SERVICE LETTER: JSL 005-1
Issue: 1
Date: 1st September 2008
Subject: Starter Motor Earth Cable

Jabiru Service Letter: Starter Motor Earth Cable

Figure 1: Cable to Engine Backing Plate

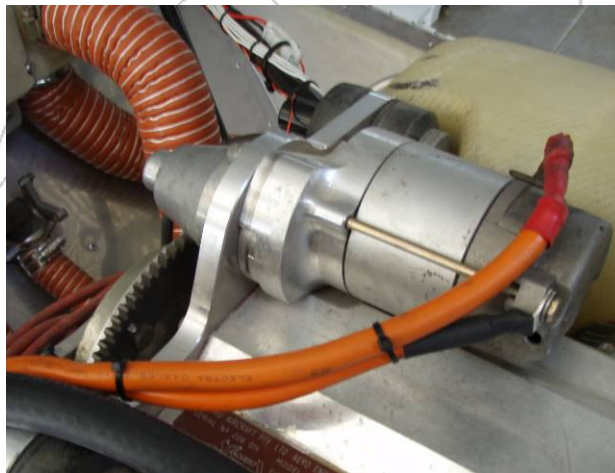
Shown below in Figure 1 is (on left) a typical starter motor installation and the modified installation (on right). In the typical installation the motor's earth cable is connected to the backing plate of the engine. The modified installation connects the earth cable directly to the starter motor end cap.

- a) Remove the cable from under the cap screw on the engine backing plate.
- b) Re-fit the cap screw to the engine backing plate. A washer must be fitted underneath the head of the screw.
- c) Before installing, clean any grime or corrosion off the mating surfaces of the motor and the cable to ensure a good electrical connection
- d) As this is a 3/16th bolt a larger washer under the head is required to ensure good contact.

- e) Clean the thread of the starter motor through-bolt, removing old Loctite.
- f) Fit the cable under the head of the bolt that holds the starter body together. Apply a small amount of Loctite 242 (approximately the size of a match head) or equivalent to the starter motor through-bolt thread on assembly.
- g) It may be necessary to cut some cable-ties and re-route the cable slightly to gain sufficient length to reach the end of the starter motor.
- h) Once the cable is connected, apply zip-ties as required to restrain the cable. If possible, Zip-tie the cable to the starter motor through-bolt as shown in Figure 1. An alternate cable restraint is shown in Figure 2 and may be used where there is not enough cable length for Figure 1-type restraint. Use Zip-ties to restrain all excess cable loops.
